# TOTALFLOW

## *Technical Bulletin 126*

### Switched Voltage battery (Vbatt) Issue on Model 6200 microFLO and XSeries Products

#### Totalflow Technical Bulletin

## microFLO wiring diagram showing Switched Vbatt signal when communications termination board is installed.

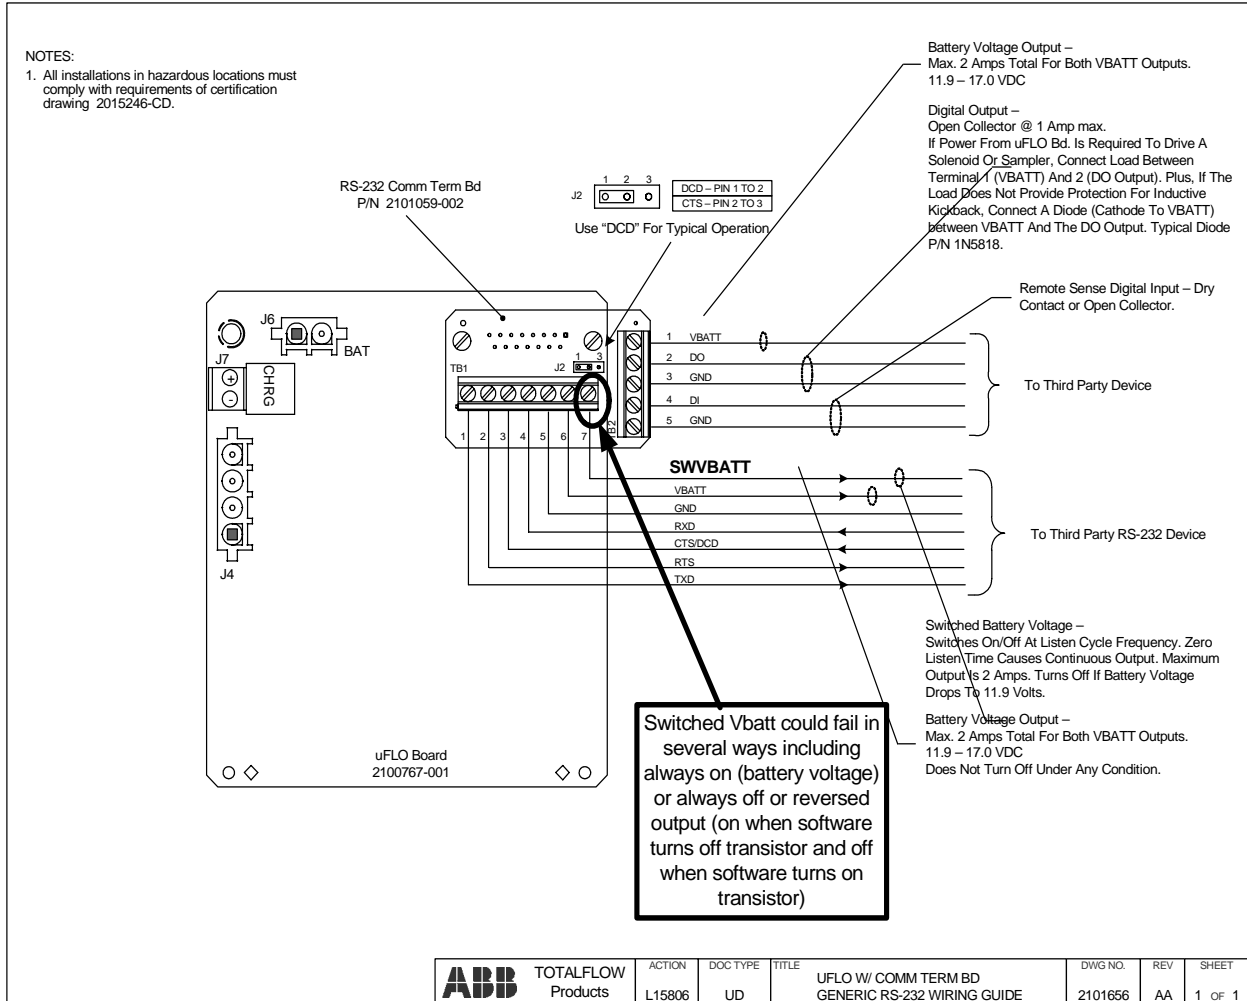
A small number of microFLO 2100767-xxx, XFC 2100204-xxx and XRC 2100355-xxx electronic boards have been returned with Switched Vbatt's field effect transistor (FET) blown. The symptoms will vary depending on how the FET fails and include:

- Switched Vbatt always on (measuring battery voltage)
- Switched Vbatt always off (zero volts)
- Switched Vbatt reverses states, off (zero volts) when Flow computer attempts to turn on external device and on (battery voltage) when Flow computer attempts to turn off external device.

It is believed that the failures may be due to a bad lot of vendor supplied FET's. We do not believe these failures are due to excessive current consumption because 1) the circuit is protected by a 2 amp fuse and 2) some number of failures have occurred on sites where Switched Vbatt was sourcing less than 20 milli-amps of current.

There is still some uncertainty on what is causing the Switched Vbatt failures even though it is believed that a bad lot of components caused the failures. ABB changed the Switched Vbatt component as a precautionary step to ensure the highest product quality. This new FET has higher reliability specifications than the original component. All new products and any future repairs will be switched to this new part.

### XFC (P/N 2100204-xxx) Switched Vbatt Signal Diagram

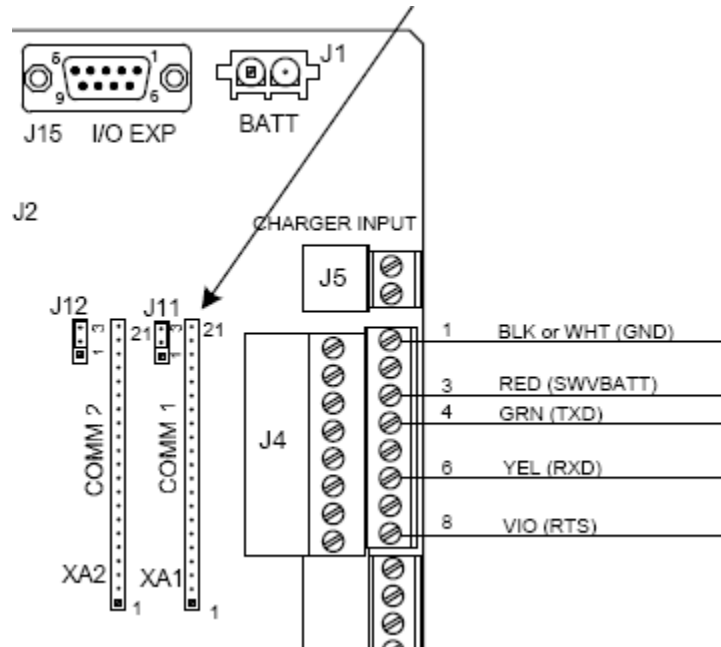
J4 pin 3 = Switched Vbatt for Communications port #1 and port #2
